Heceta Self Storage Corporation- Unshilded Lighting Fixtures and Barbed Wire Fencing

Heceta Self Storage Corporation (Kingwood St.)

PC 20 30 DR 07

TYPICAL LINE FENCE DETAIL

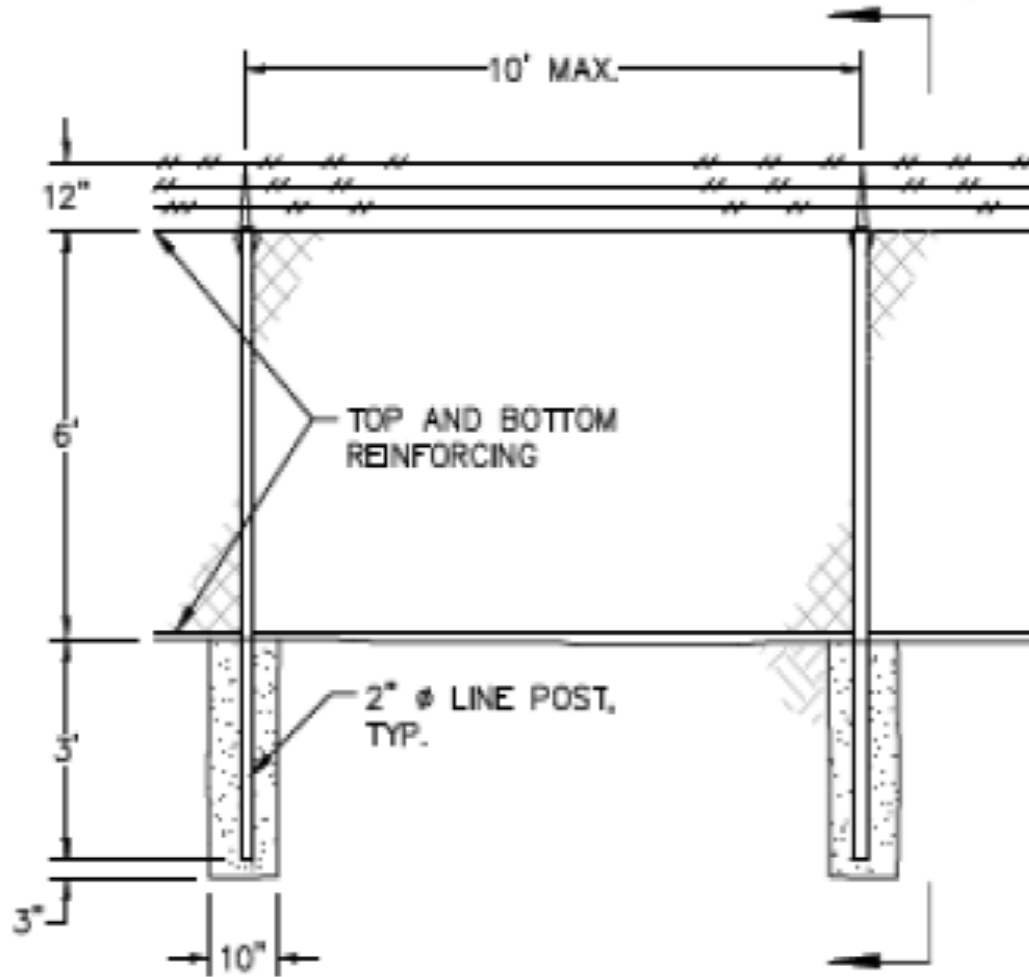
Proposed Barbed Wire Fencing Example

FCC 6-1-7-14: A. [...] Barbed wire fencing may be permitted on commercial, [...] property at the discretion of the Planning Commission/Design Review Board only if the following criteria are met: [...]

1. Additional security is warranted for health and safety reasons and cannot be addressed by standard fencing or other security measures

2. The fencing is constructed in a way to cause the least hazard to employees and citizens in its non-deterrent mode.
3. The potential risk of injury from the fencing is less than the risk contained within the business site.
4. There is no feasible alternative.

1. Is the barbed wire fencing as proposed needed for safety and/or security reasons?
2. Do the unshielded lights meet the code when considering the criteria and definitions together?

PROPOSED LIGHT EXTERNAL LIGHT FIXTURE FOR STORAGE UNITS

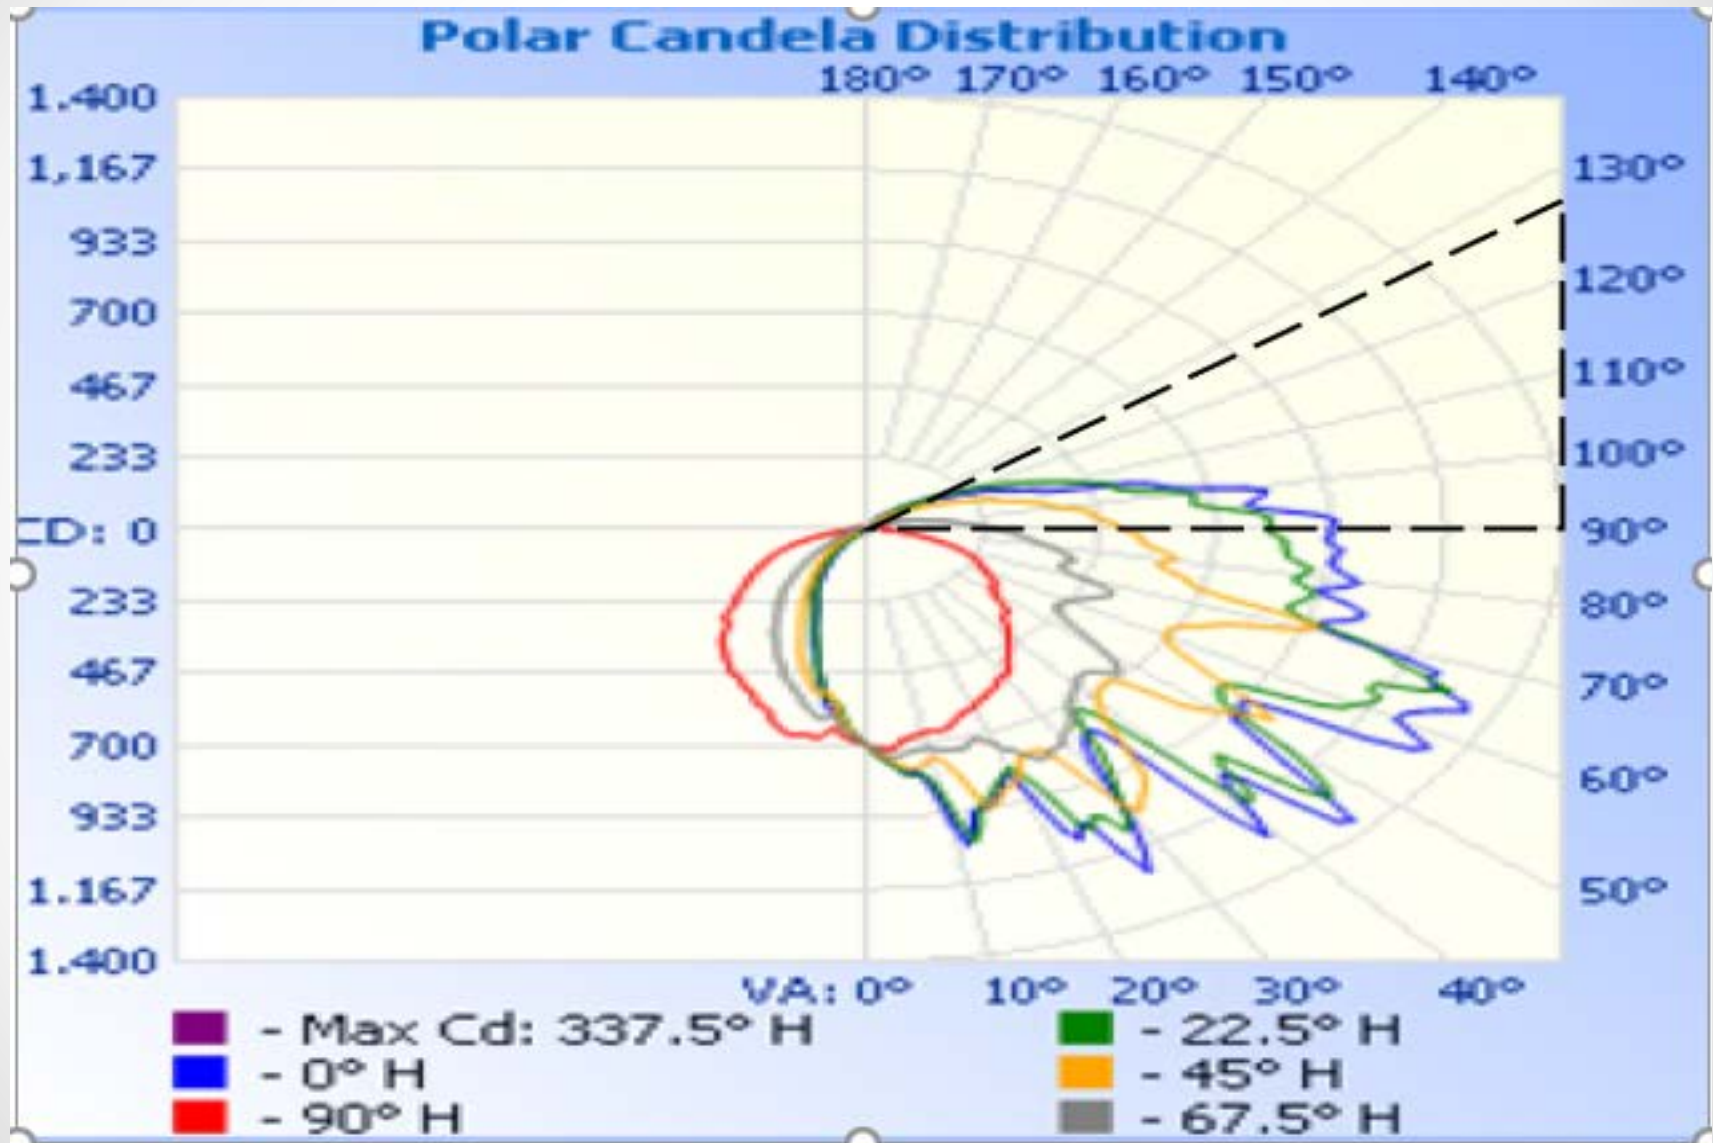
FCC 10-37-4: A. All exterior lighting fixtures...must be designed as a full cutoff fixture or have a shielding method to direct light emissions downward below the horizontal plane onto the site and does not shine illumination or glare skyward or onto adjacent or nearby property." *TFCCher*

4. **(If lighting is approved)** The applicant shall ensure that lighting be extinguished at the end of business hours except as needed for safety in accordance with FCC 10-37-4 D.
